To: Natural Resources Wales
From: Jen McMillan
Date: 25 February 2020
Copy: James Orme, Graham Morley
Our reference: PB5034-RHD-ZZ-XX-NT-Z-1000
Classification: Project related

Subject: Updated assessments for terrestrial ecology (excluding chough) in response to comments made on the Environmental Statement by NRW and RSPB: draft for discussion in meeting schedules 28/2/2020

132kv Cable Route & Joint Pit Location

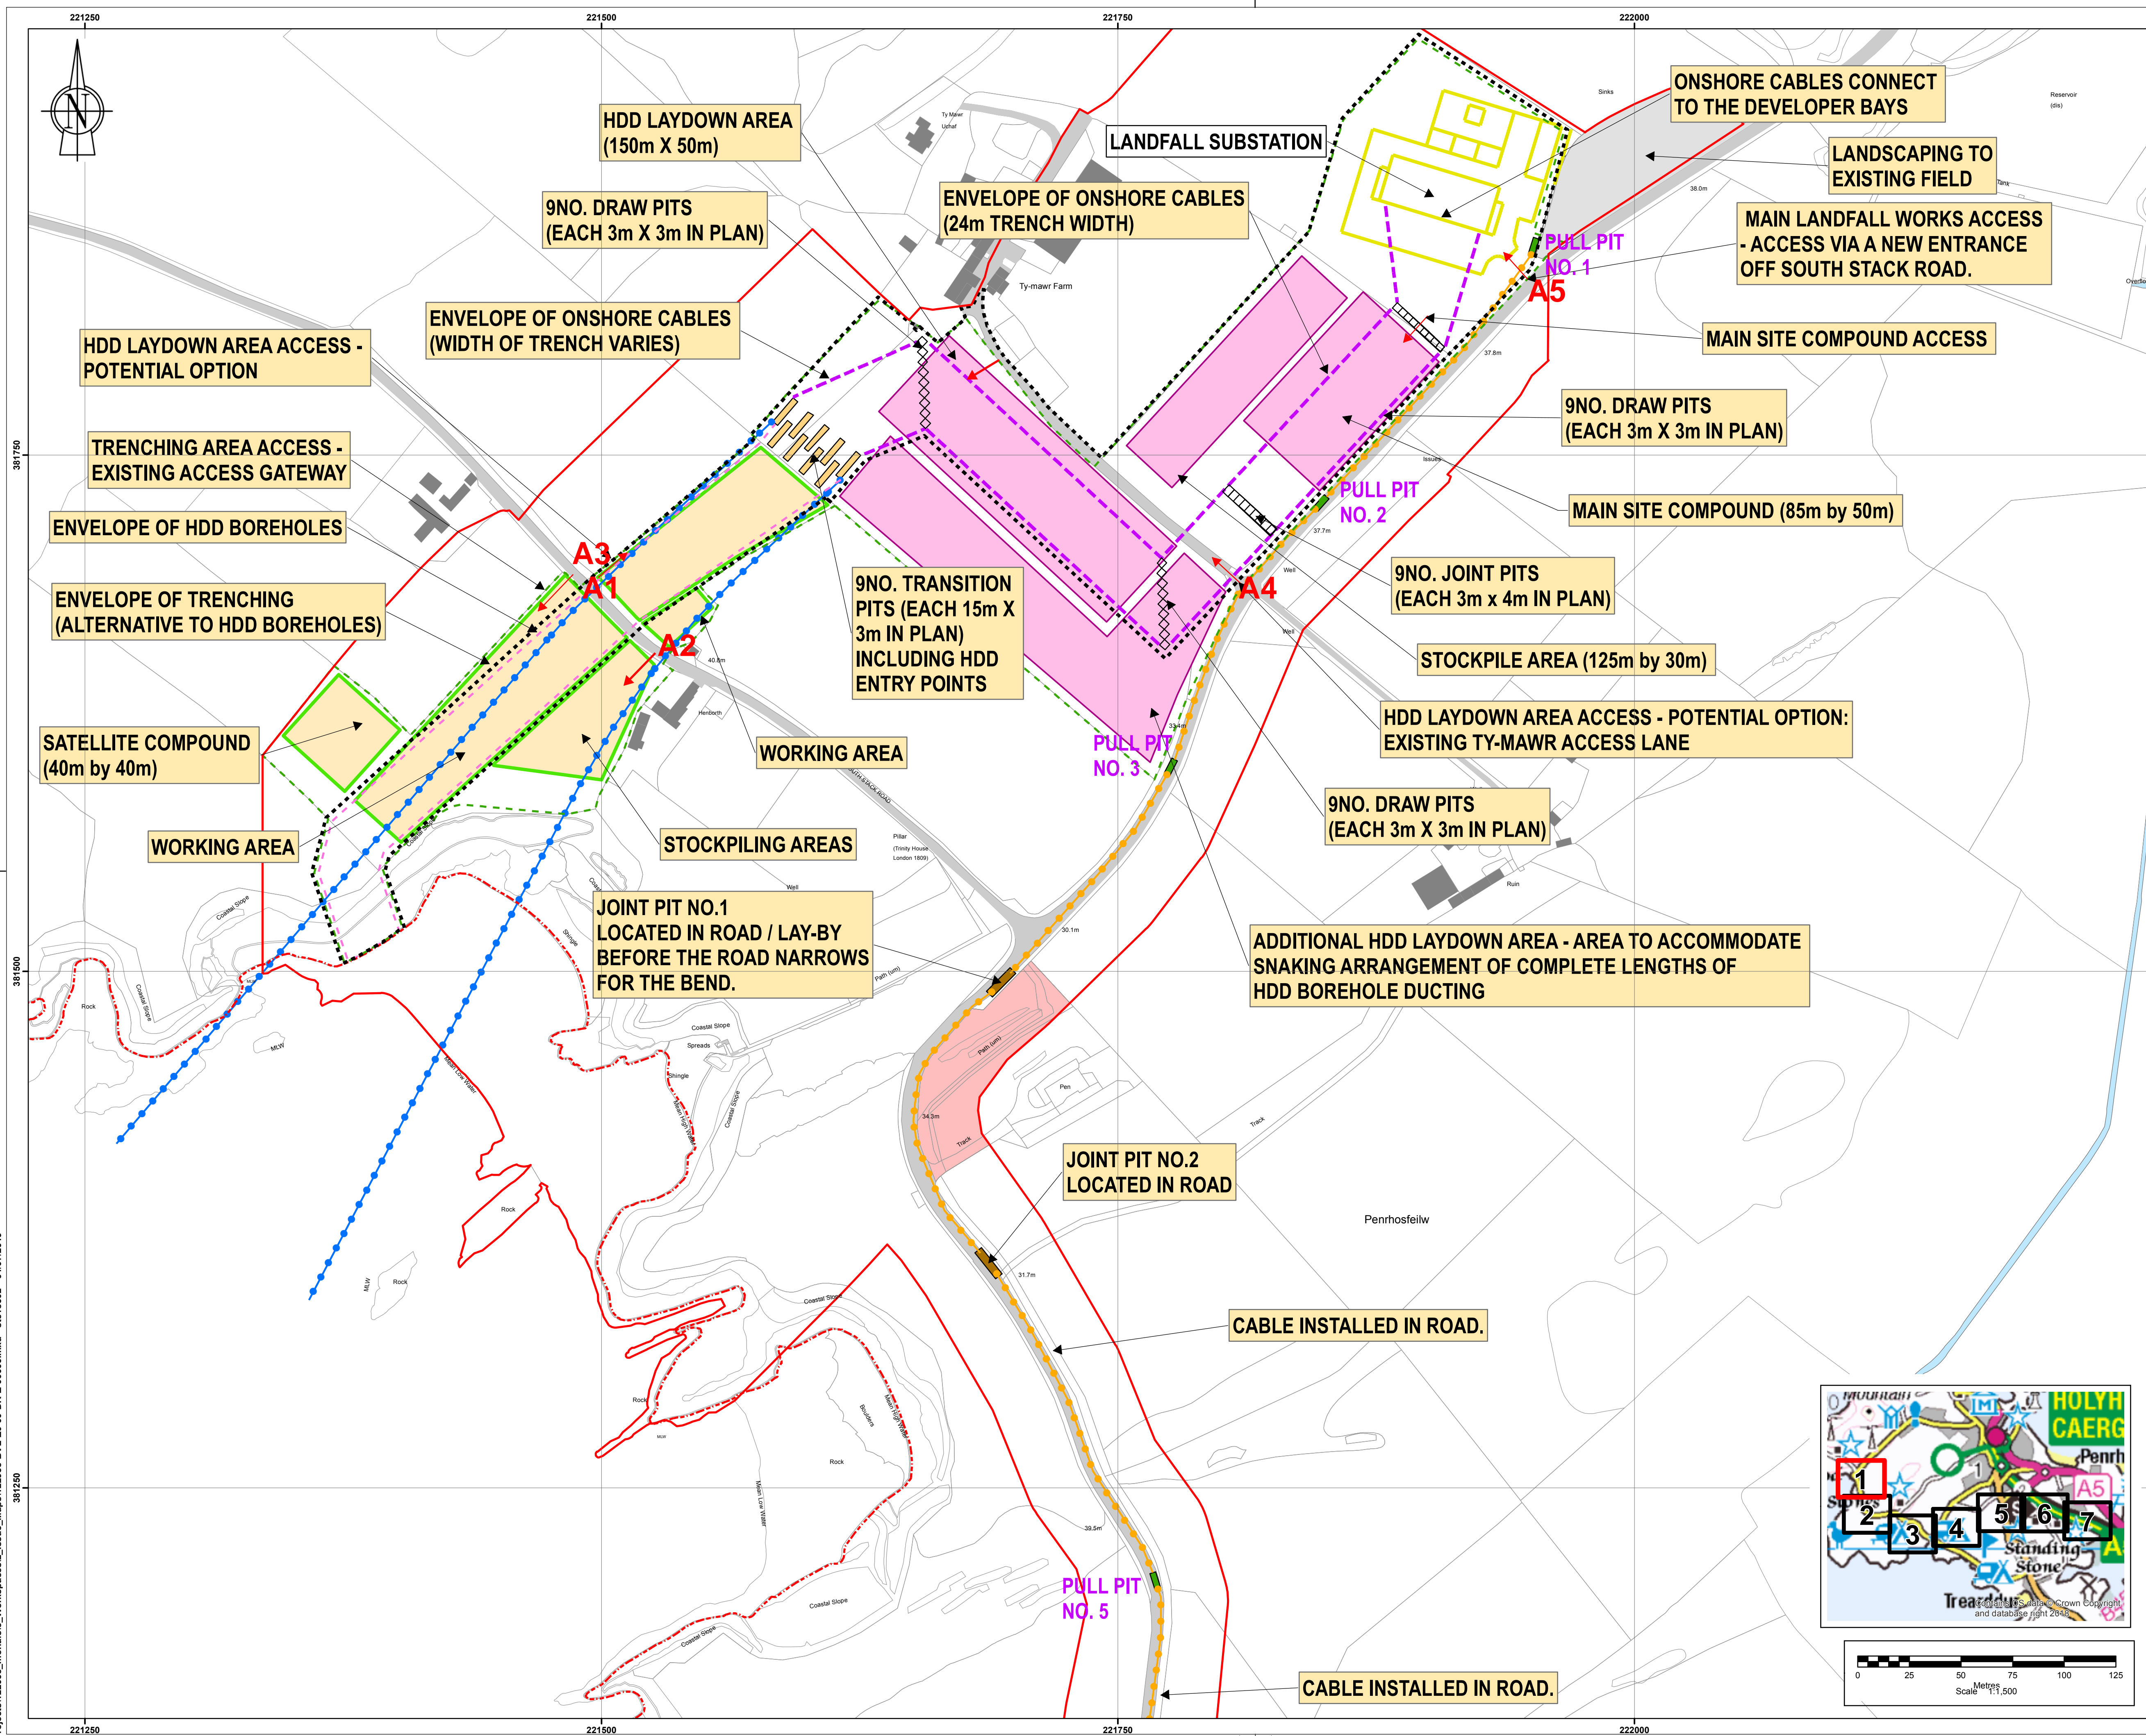
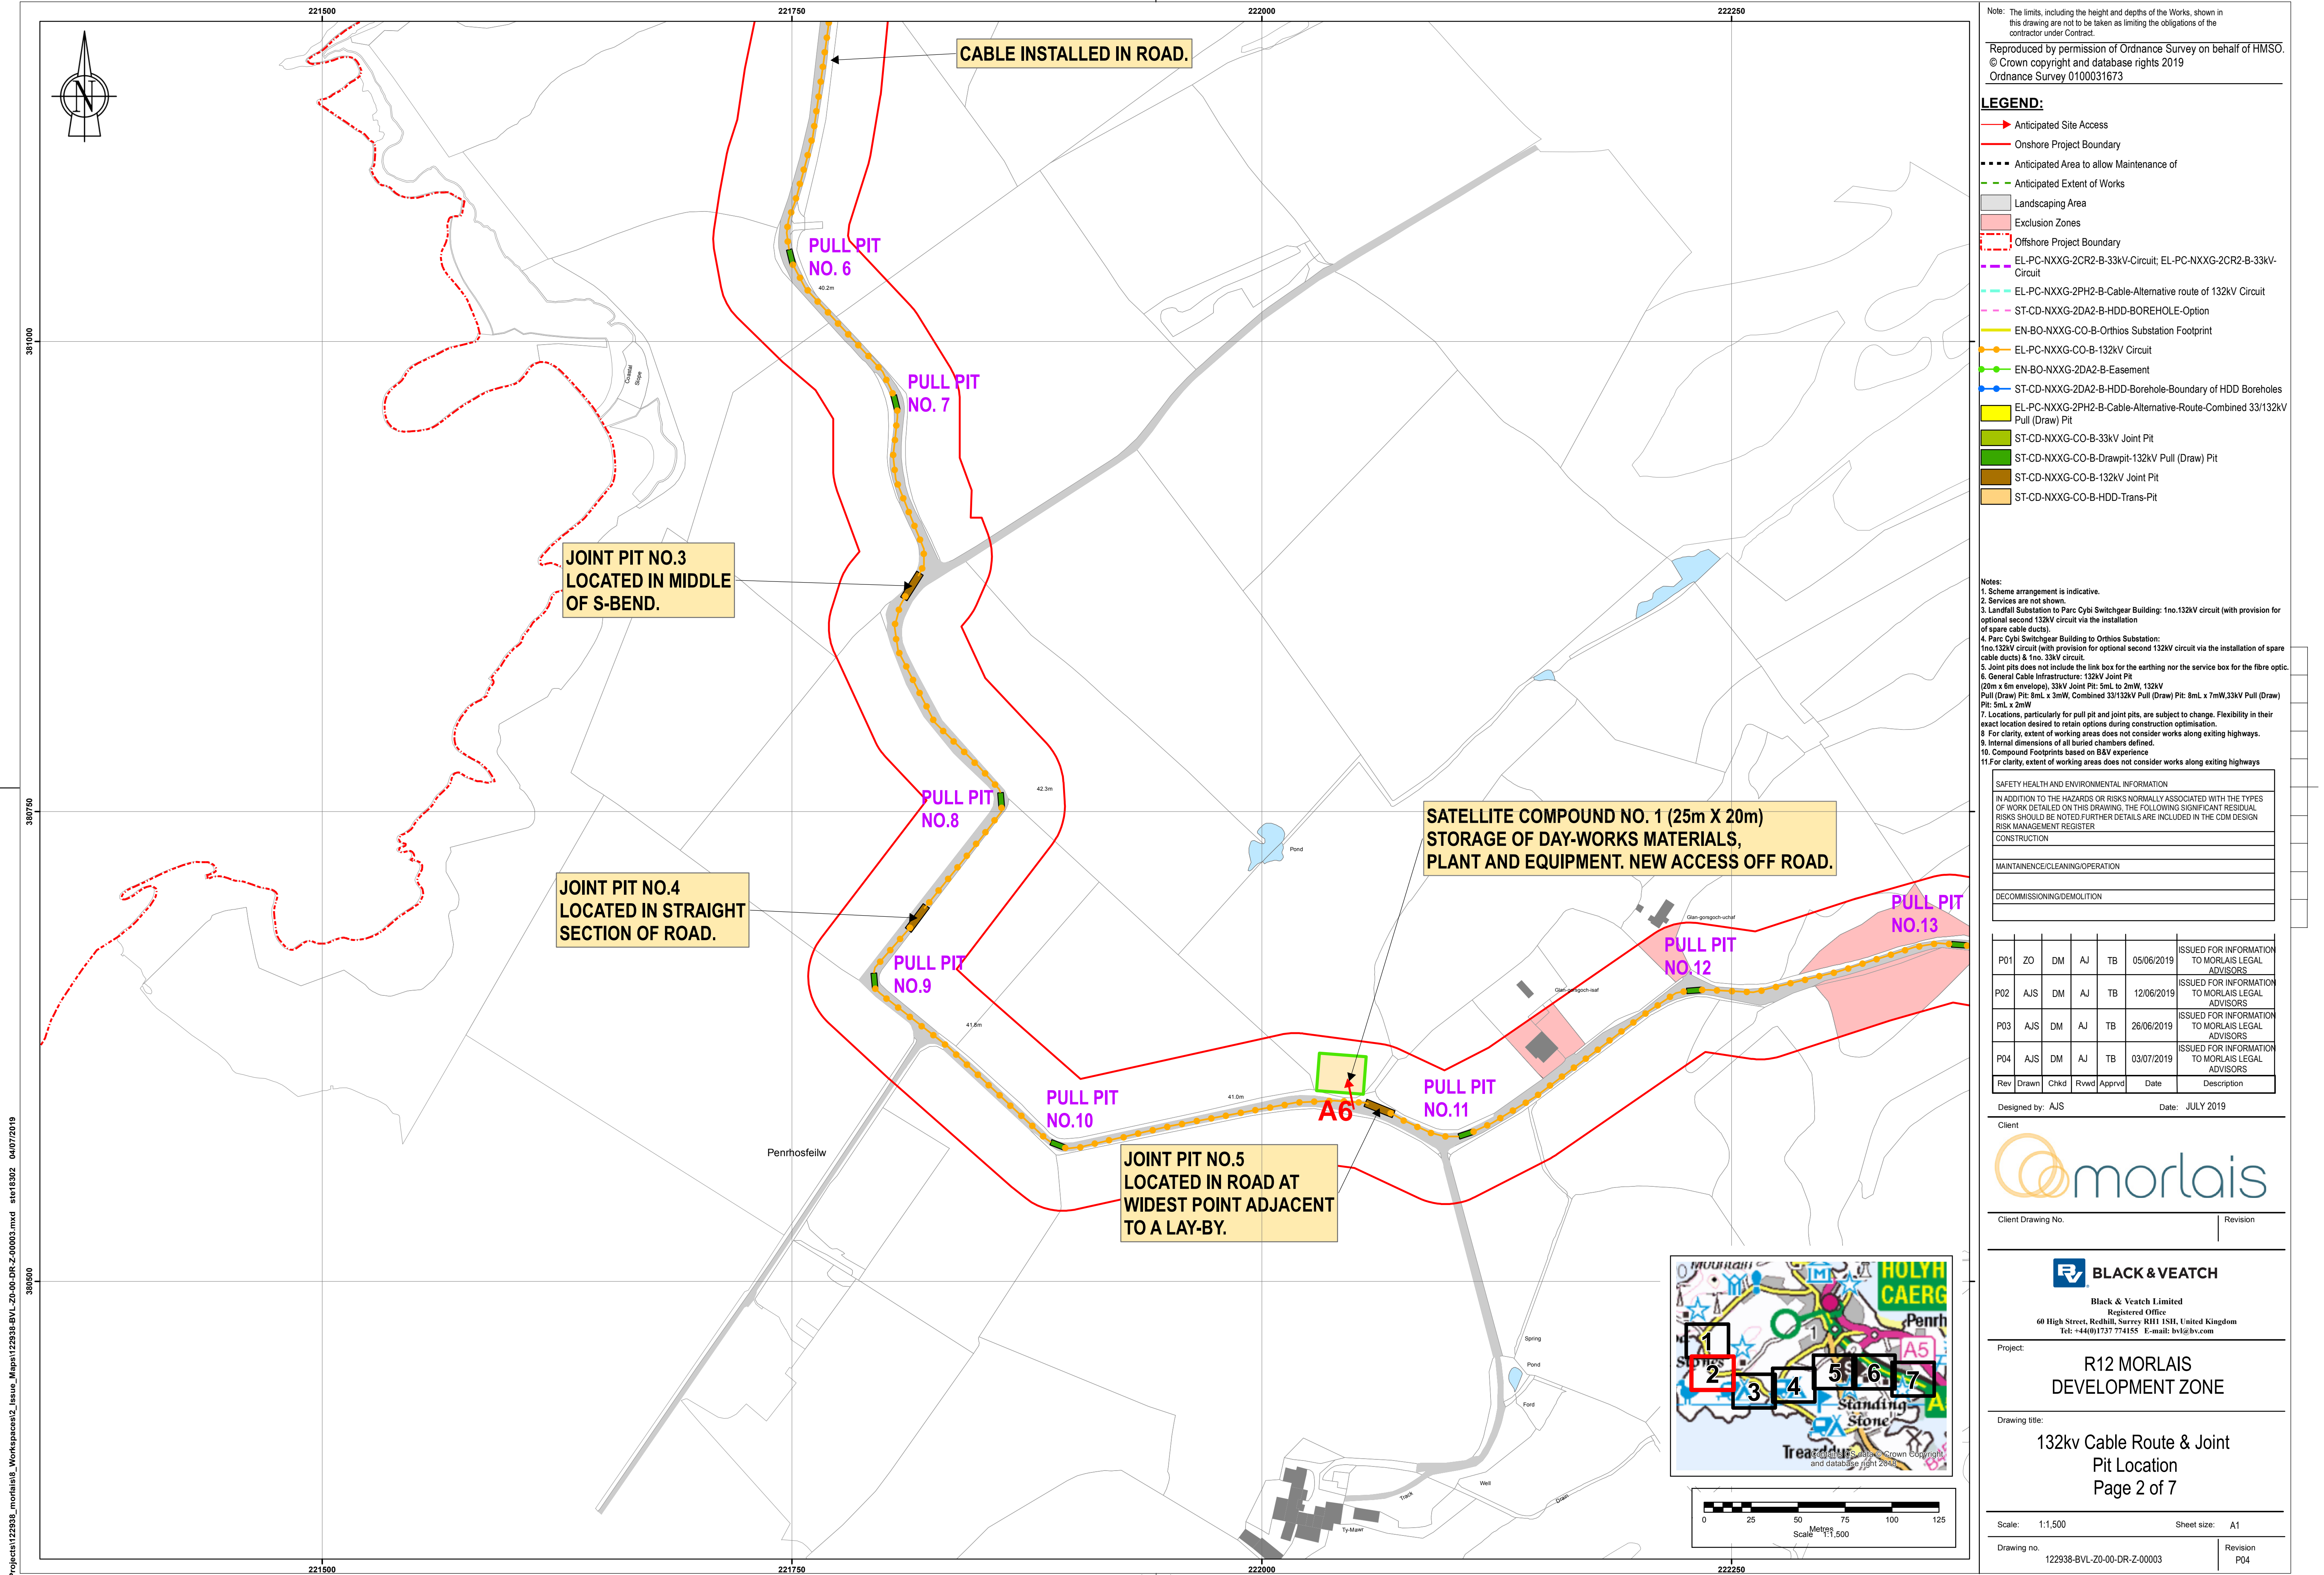
27	Paragraph 997: It should be stated here that not only will materials and equipment be stored within the construction footprint, but they will be stored outside the designated site boundary.	Methodology updated in Section 5 of this document to include for no storage in the designated site boundary
28	We advise that further work to reduce the impact on hedgerow and cloddiau due to their removal is made - possibly using HDD at these locations. NRW would expect that if the removal of any hedgerow or cloddiau cannot be avoided, a licenced ecologist or Environmental Clerk of Works (ECow) should be on site to provide the necessary expertise. The qualifications, licencing and contact details for this person should be forwarded to NRW as early as possible. NRW would expect this person to be the main point of contact for all ecological matters during this work.	Mitigation updated in Section 7.1 of this document to use trenchless crossings for cloddiau and any sensitive hedgerows

This section should be read alongside Drawing 2: 122938-BVL-Z0-00-DR-Z-00003.

Two out of the proposed nine draw-pits will be located within the unimproved neutral grassland, the other seven being located within the poor semi-improved grassland. It is proposed to leave all nine manhole covers in place, to reduce temporary disturbance to the habitat during planned or unplanned maintenance events. The footprint of the manhole covers, and the nine ground anchors will result in permanent habitat loss as presented in Table 6.2.. There will be no laydown areas for plant or equipment within the neutral grassland habitat, recognising that this habitat is considered to be of high sensitivity.

In response to consultation undertaken with NRW, who raised concerns regarding the impacts associated with the removable and re-construction of cloddiau, trenchless methods will be now employed to cross under cloddiau to avoid direct impact to these features. Consequently, there will be **negligible** impact upon the cloddiau features.
